# DEVELOPMENT REVIEW BOARD REPORT

**21-DR-2005**  
**Comerica Bank**

Request approval of a site plan and elevations for the construction of a new bank.

## **Stipulations for Case: Comerica Bank Case 21-DR-2005**

WEST ELEVATION SOUTH ELEVATION	
A4	
DATE: 05/05/05	SCALE: 1/4" = 1'-0"
BY: CB	CHECKED BY: AJ
DATE: 05/05/05	SCALE: 1/4" = 1'-0"

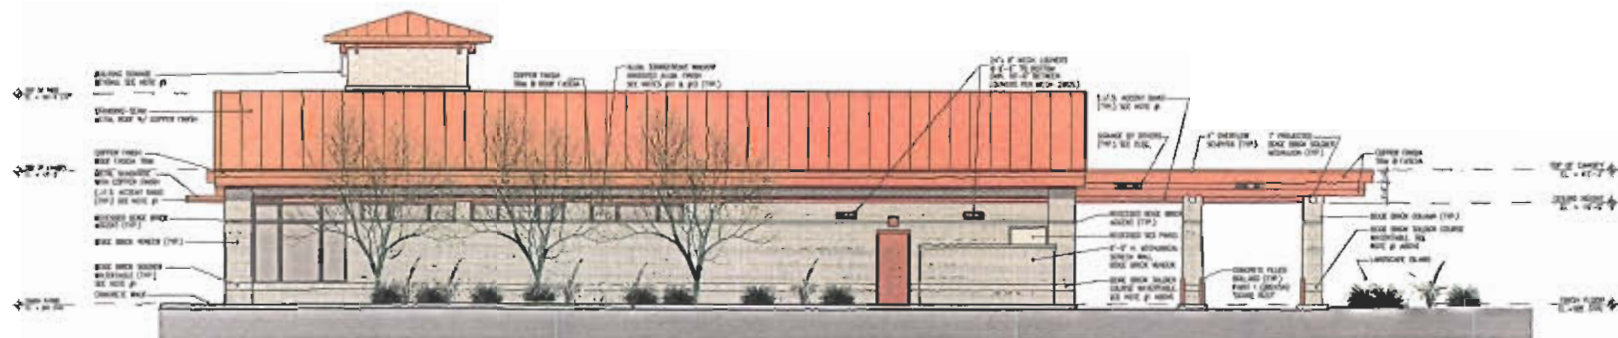
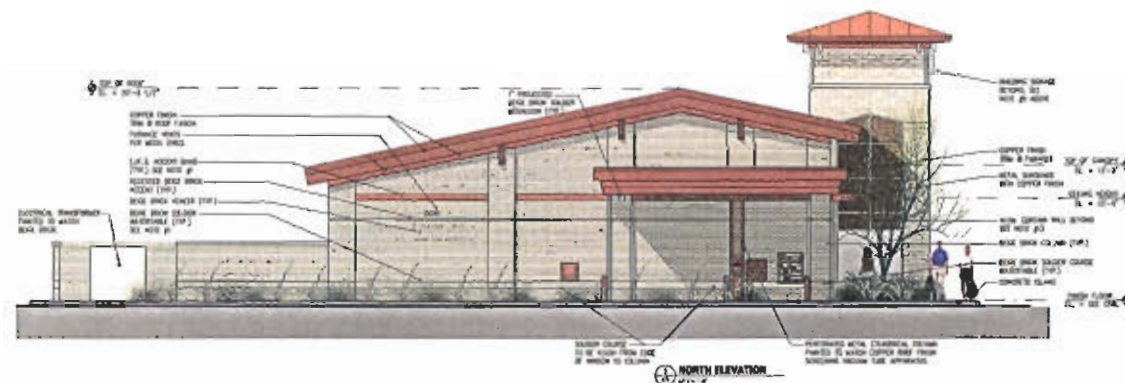
- a. Architectural elements, including dimensions, materials, form, color, and texture, shall be constructed to be consistent with the building elevation sheets A4 and A5 submitted by DWL Architects with staff receipt and seal dates of 5/6/2005.

11. Perforation of the aluminum curtain wall shall not exceed 50%.
12. The bottom of the aluminum curtain wall on the west elevation at the entry tower element shall be raised to expose the storefront entry, improving the legibility of the building entrance. The bottom of the curtain shall be at a height that continues the line defined by the recessed brick accent or the lowest EIFS accent band.
13. Spandrel panels, if used, shall have an external appearance matching vision glazing.
14. The drive-thru canopy shall have a fascia board, the bottom of which is a minimum of 8 inches lower than any light fixture lenses mounted within the canopy.
